**Deep Geologic Repository Project for Low and Intermediate Level Waste –
Submission of Responses to Information Requests in Package #13**

**OPG Responses to Information Requests in IR Package #13 from
Joint Review Panel**

**POSTCLOSURE SAFETY IMPLICATIONS
OF REVISED PRESSURE TUBE INVENTORIES**

**PRECLOSURE SAFETY IMPLICATIONS
OF REVISED PRESSURE TUBE INVENTORIES**

Figure 1: Maximum Calculated Doses for the Normal Evolution Scenario Calculation Cases showing 2011 PostSA and Revised Results (Note that differences in results are too small to be visible on this scale.)

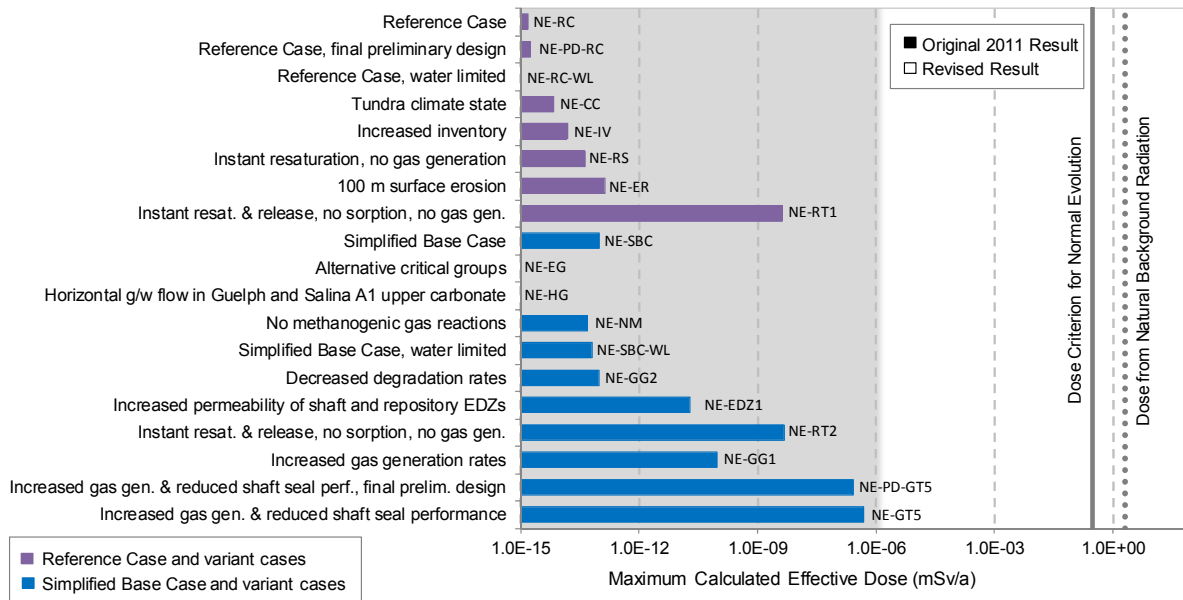
IR#	EIS Guidelines Section	Information Request and Response
EIS 13-514	<ul style="list-style-type: none"> Section 8.1, General Information and Design Description 	<p>Information Request:</p> <p><i>Provide the following:</i></p> <ul style="list-style-type: none"> <i>The results and evaluations of the re-runs of postclosure safety assessment models at a similar level of detail and clarity as that provided in NWMO DGR-TR-2011-25 "Postclosure Safety Assessment";</i> <i>An assessment of how the revised inventories will affect the pre-closure safety evaluation of the DGR, with special emphasis on the occupational health and safety of the workforce, as well as radiation protection requirements. This assessment should also address the impact of the revised inventories on the possible future expansion of the DGR;</i> <i>An assessment of how the revised inventories would affect the environmental effects of accidents, malfunctions and malevolent acts, with emphasis on the pre-closure phase;</i> <i>A Waste Inventory Verification Plan, similar to the Geoscientific Verification Plan, which provides clear objectives, activities, and time-lines of future endeavours to improve the accuracy of the Reference Waste Inventory. The response should also include any plans for an independent expert evaluation of the methodology and verification procedures; and</i> <i>Clarification of the methodology used to determine radioisotope concentrations and activity levels in filter resins.</i> <p>Context:</p> <p><i>Recent correspondence between Dr. Frank Greening and the NWMO (See CEAR numbers 1777, 1808, 1809, 1810 and 1811) has raised questions regarding the accuracy of OPG's 2010 Reference Waste Inventory of L&ILW that would be emplaced into the proposed DGR. These questions concern radionuclide concentrations in CANDU pressure tubes and garter springs for which the concentrations of some radioisotopes appear to have been significantly underestimated or not estimated at all. The underestimates appear to be due to the use of calculated values and scaling factors, rather than measured values.</i></p> <p><i>In its February 20, 2014 response to Dr. Greening, the NWMO stated that:</i></p> <ul style="list-style-type: none"> <i>the estimated tritium content of the PT waste is approximately 300 times higher than in the 2010 Reference Waste Inventory.</i> <i>an inventory estimate of Cm-244 is not included in the 2010 Reference Waste Inventory. Cm-244 is the dominant PT transuranic radionuclide in terms of activity at reactor shutdown.</i> <i>for the pressure tube wastes, the values for Cs-134 and Sb-125 are low by a factor of 3-4, and Cs-137 is significantly underestimated by a factor of 2300.</i>

In addition to the increased inventory for some radionuclides, the model for radionuclide release from the pressure tubes has also been changed; the revised model explicitly represents some of the radionuclides as being present as surface contamination on the pressure tubes, such that the inventory for these radionuclides is released more quickly (Section 3). Table 4 and Table 5 demonstrate that these changes, combined with the changes in the inventory for some radionuclides in the pressure tube waste stream, only have a small effect on the maximum calculated doses; the changes are small enough to not be discernible in Figure 1 and Figure 2.
